# ADDENDUM NO. 2

**August 31, 2023**

## **New Buffalo Elementary Kitchen Renovation & Addition**

This Addendum consists of pages ADD 2-1 through ADD 2-2 Specification Sections 00 20 00 Information Available To Bidders, 01 32 00c Schedules and Reports, and 01 12 00 Multiple Contract Summary, and attached TowerPinkster Addendum No. 2 dated August 30, 2023, consisting of 1 page, Specification Section 10 4413 Fire Protection Cabinets, revised Specification Sections 08 3313 Coiling Counter Door and 10 2800 Toilet, Bath, and Laundry Accessories, and revised drawing sheets: G 001, A 101, A 501, ED 101, E 101, E 301, E 302, L 103, L 104.

SHEET TITLE  
FIRST FLOOR ELECTRICAL DEMOLITION

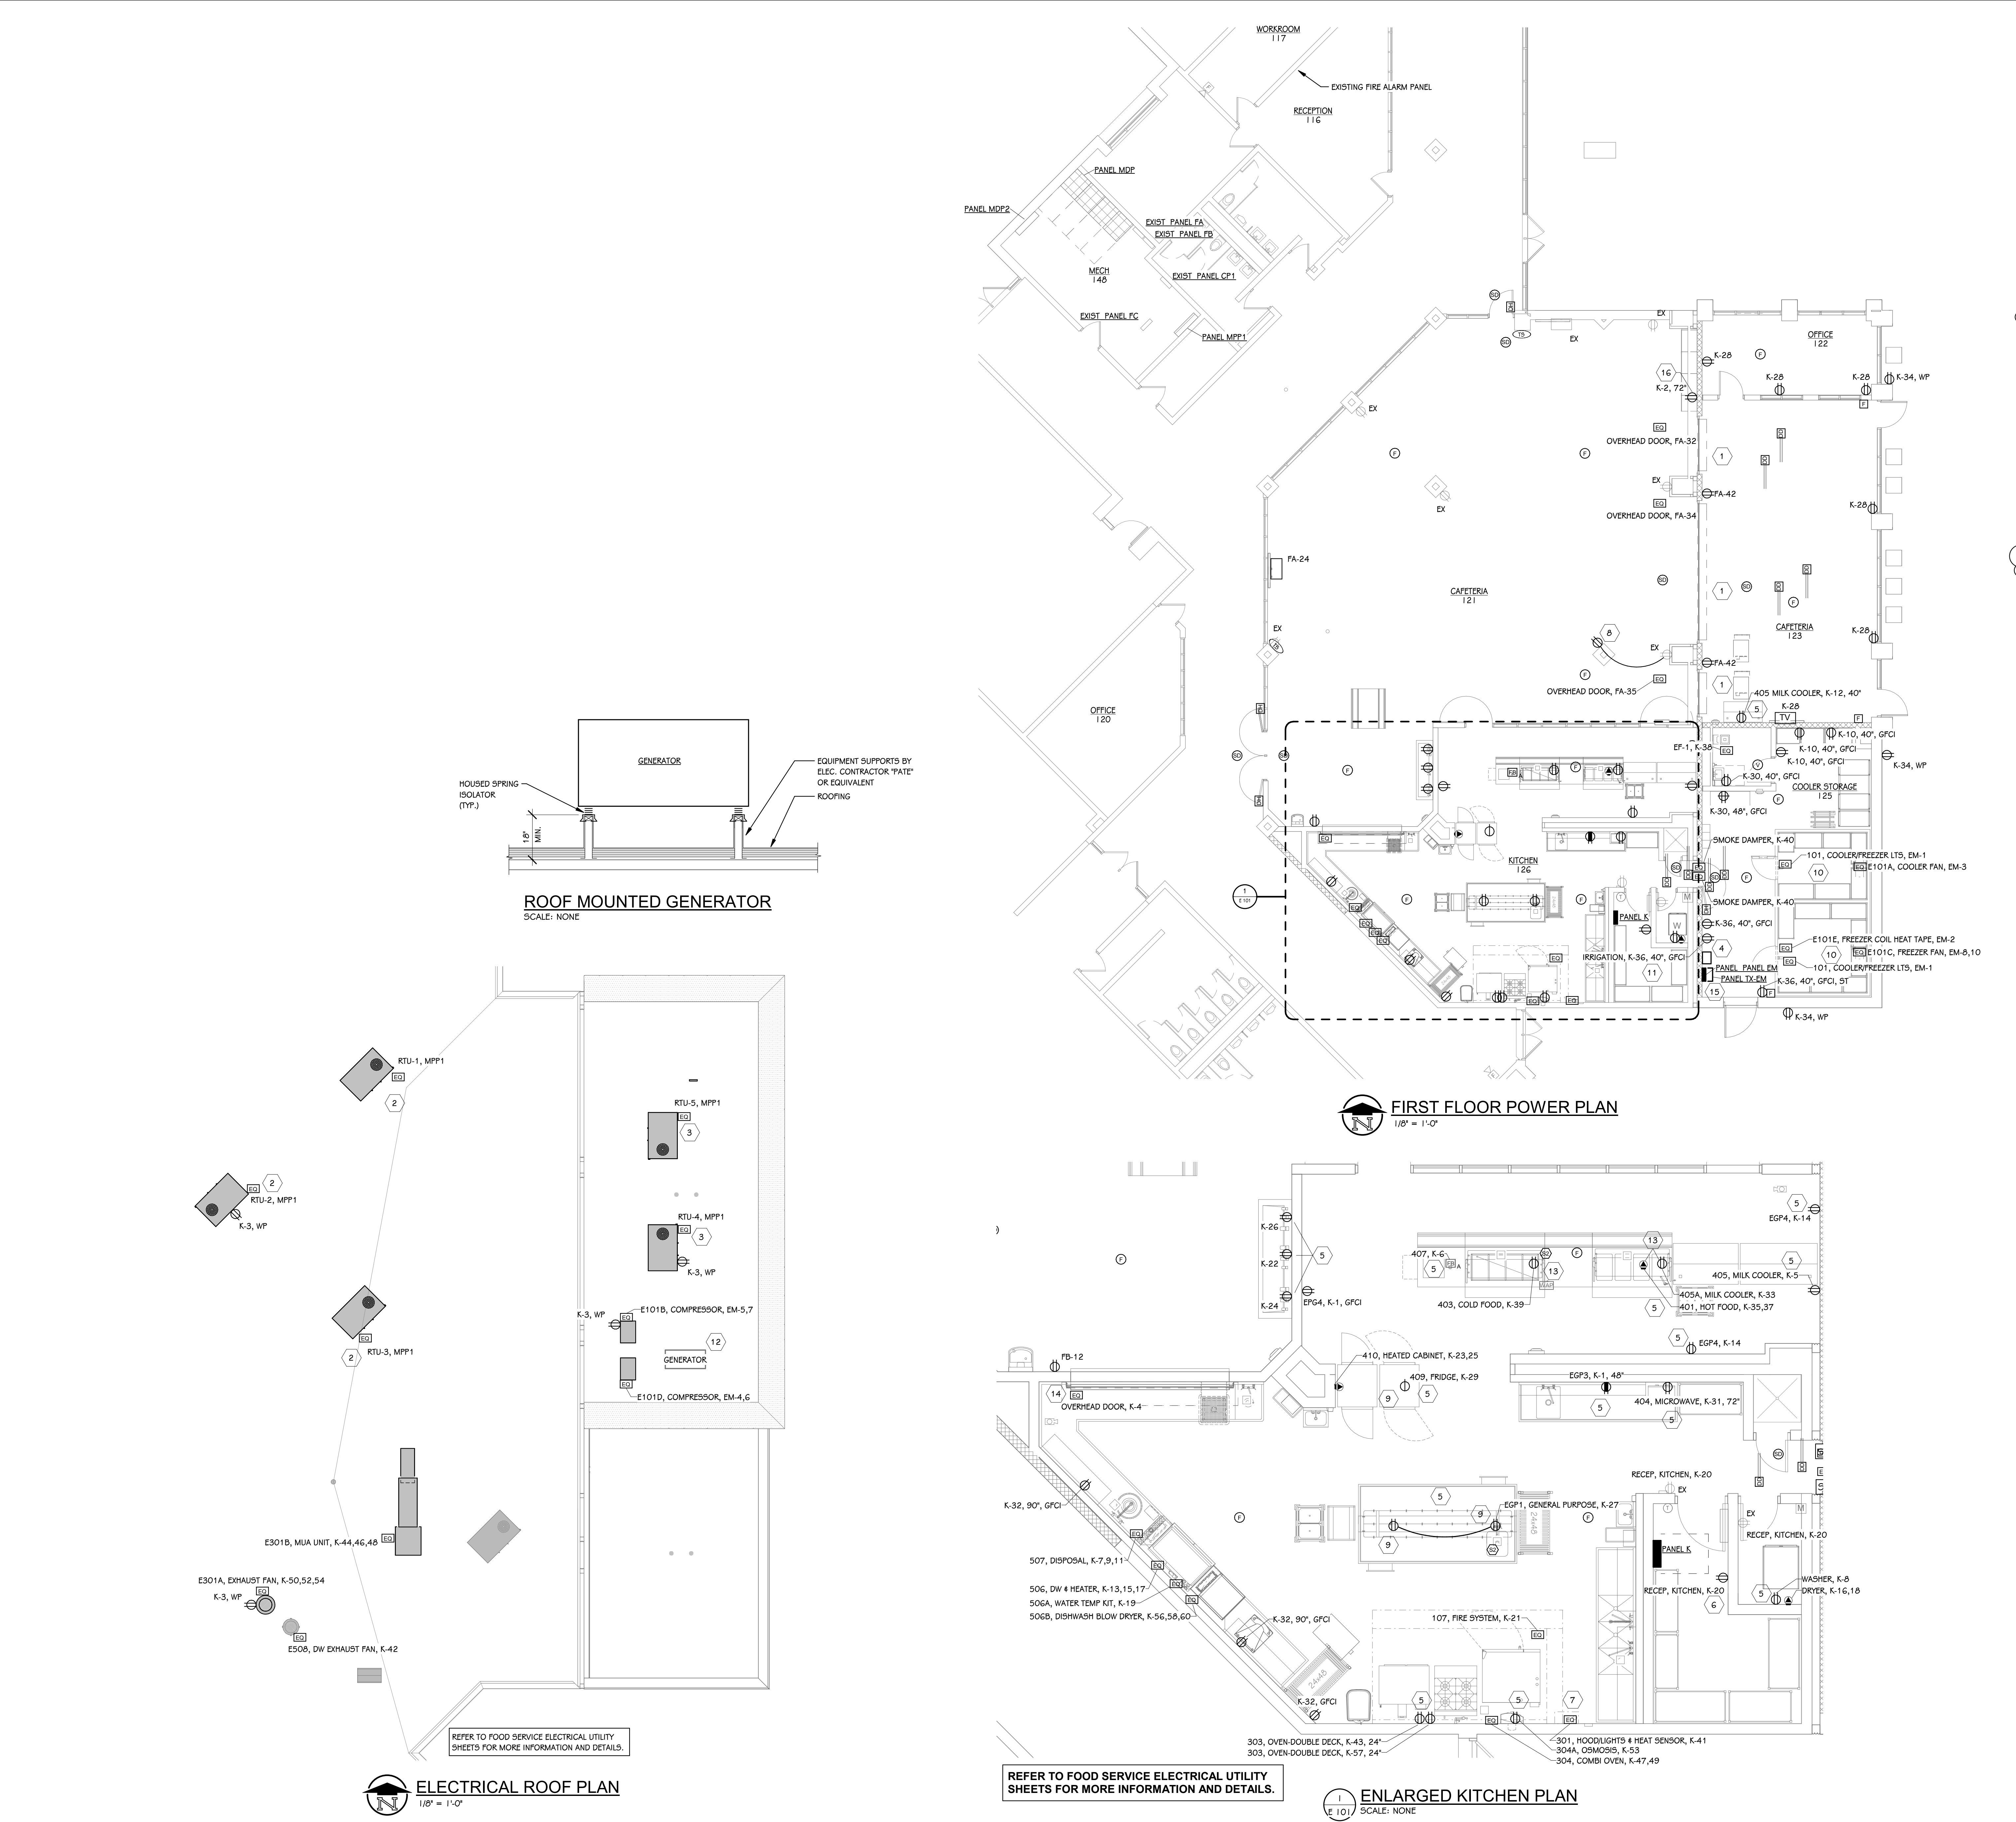
**ADD-2 Item No. D-3 - Revise Fire Alarm Information**

Refer to Sheet(s): ED 101, E 101, E301, E302

Revise the demolition plan and new power/fire alarm plan to omit reference to existing fire alarm system. Remove the existing fire alarm system in its entirety and provide an all new system per sheet E 301. Connect the new hood and roller doors to the new system.

SHEET TITLE  
EXISTING OVERALL FIRE ALARM PLAN

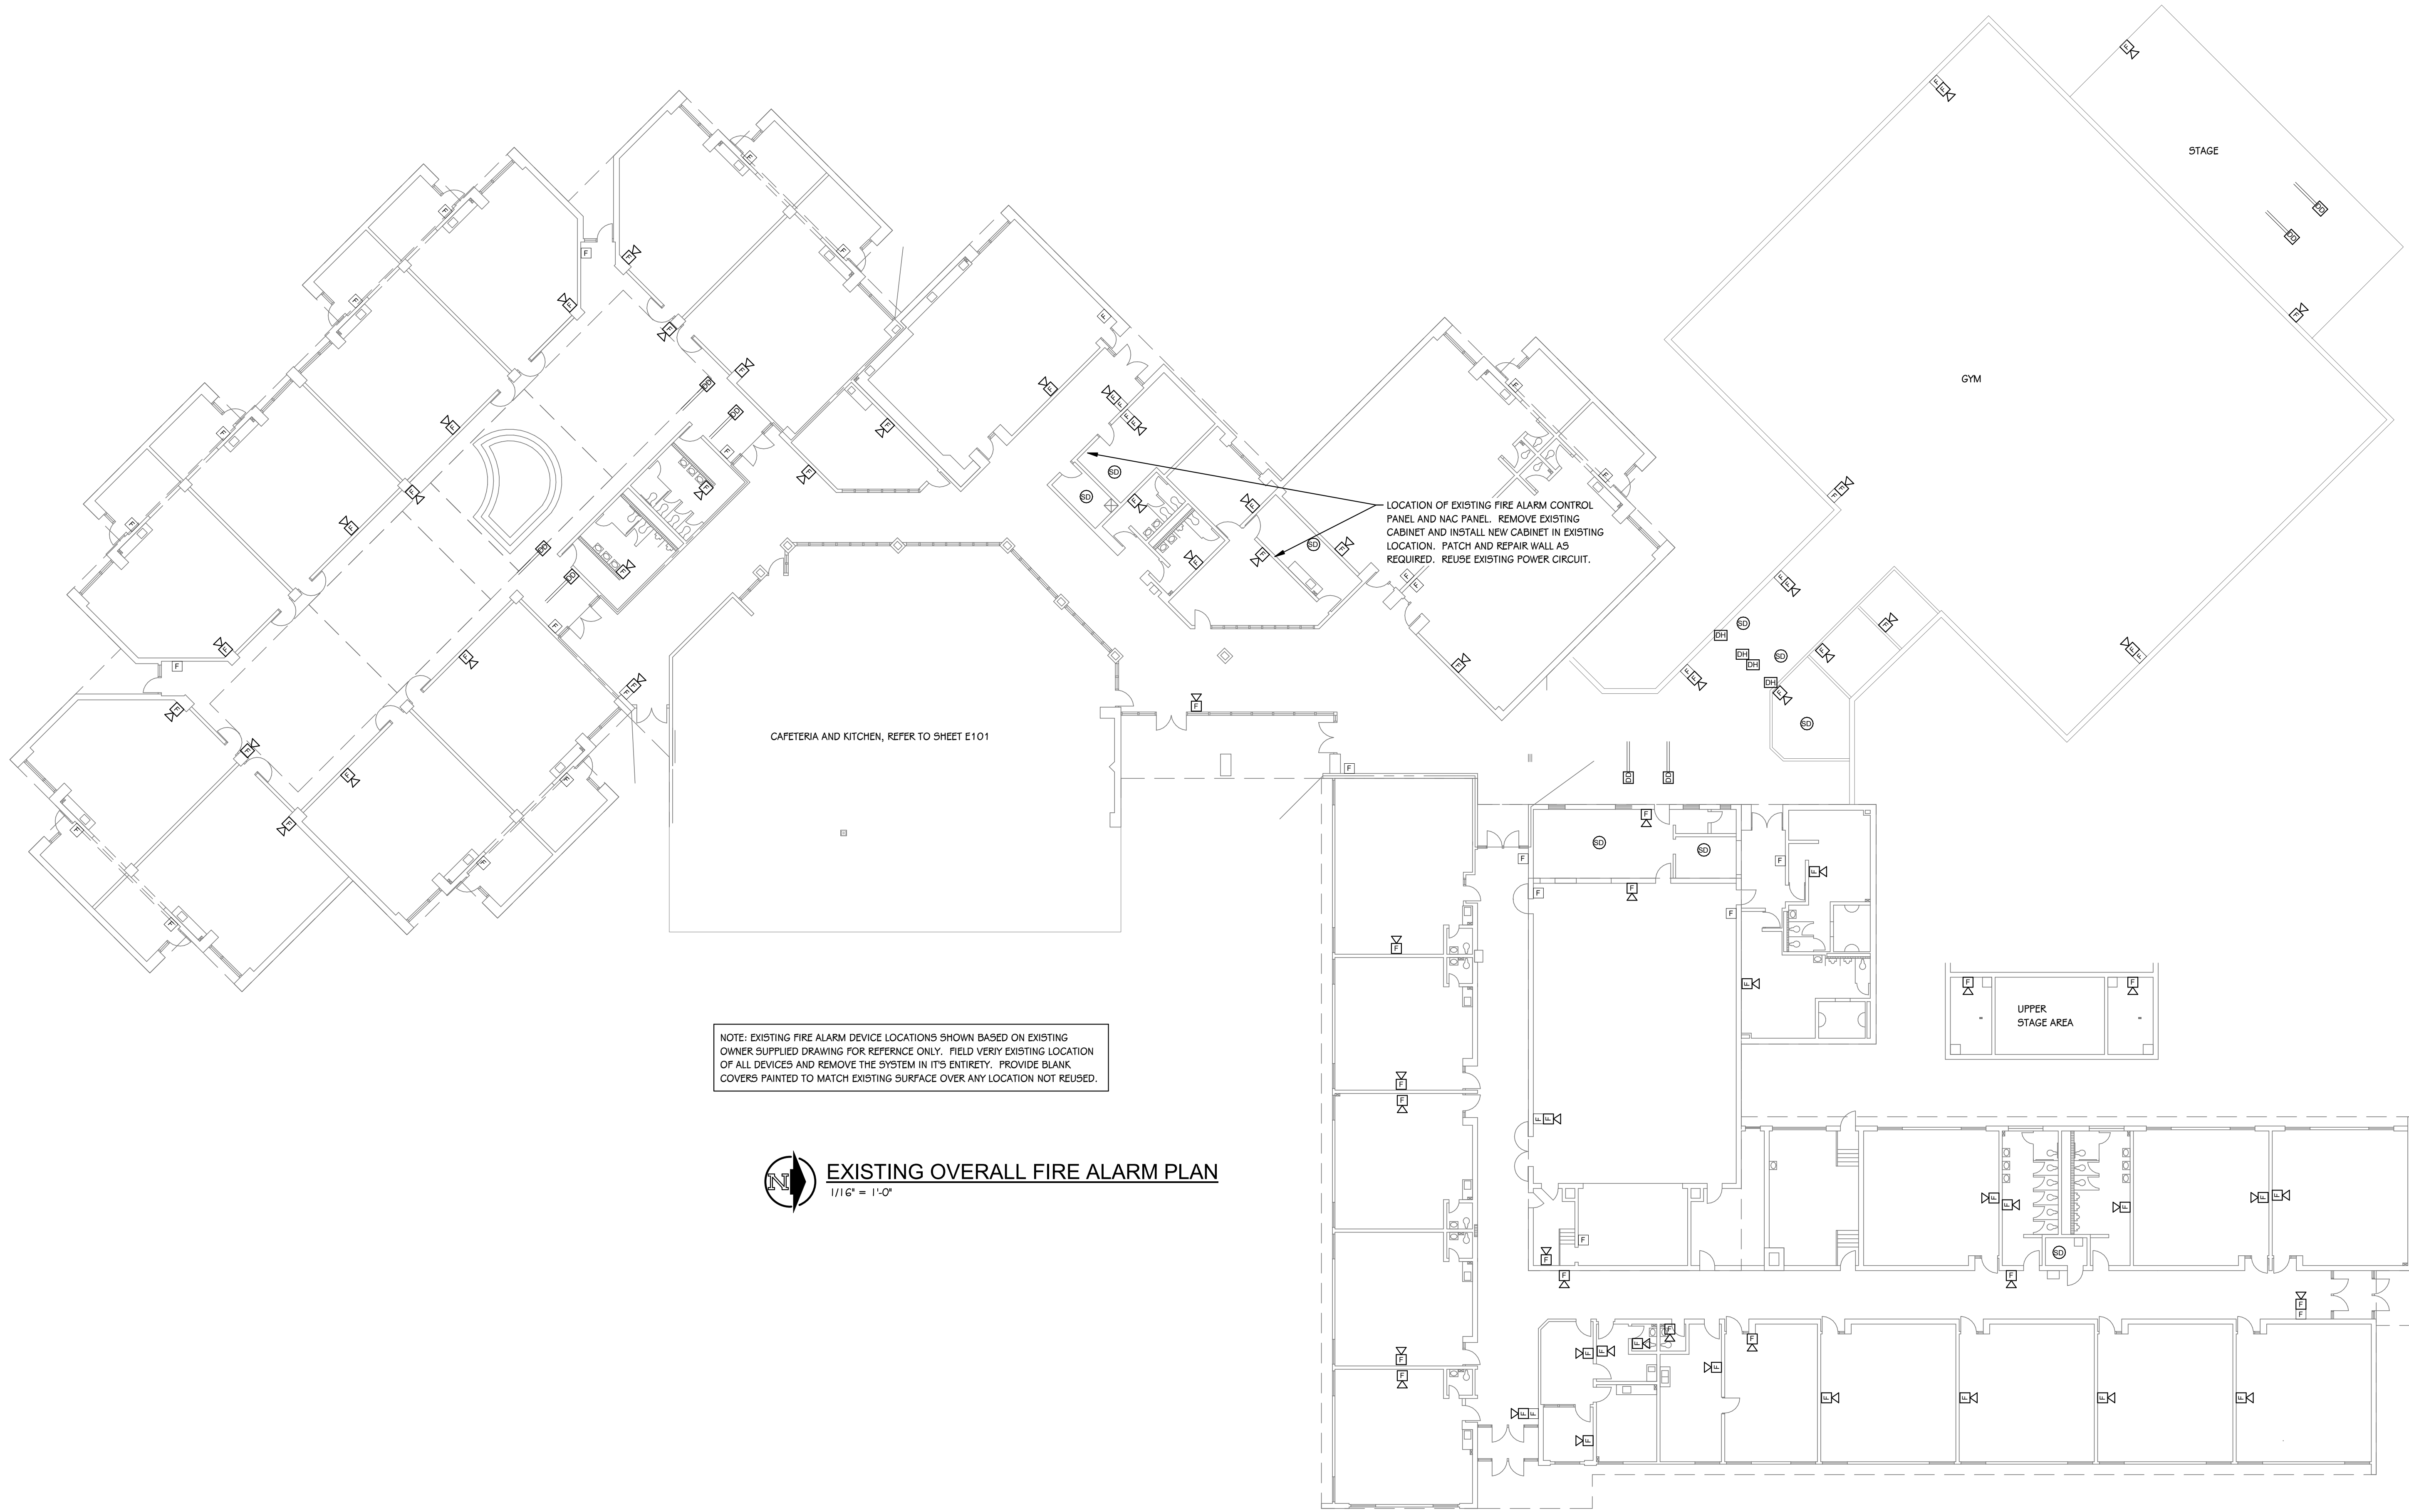
Add sheet E 302 to show location of existing fire alarm device for refence only. Add note to provide a blank cover over location not reused as shown.

NOTE: EXISTING FIRE ALARM DEVICE LOCATIONS SHOWN BASED ON EXISTING OWNER SUPPLIED DRAWING FOR REFERENCE ONLY. FIELD VERIFY EXISTING LOCATION OF ALL DEVICES AND REMOVE THE SYSTEM IN ITS ENTIRETY. PROVIDE BLANK COVERS PAINTED TO MATCH EXISTING SURFACE OVER ANY LOCATION NOT REUSED.
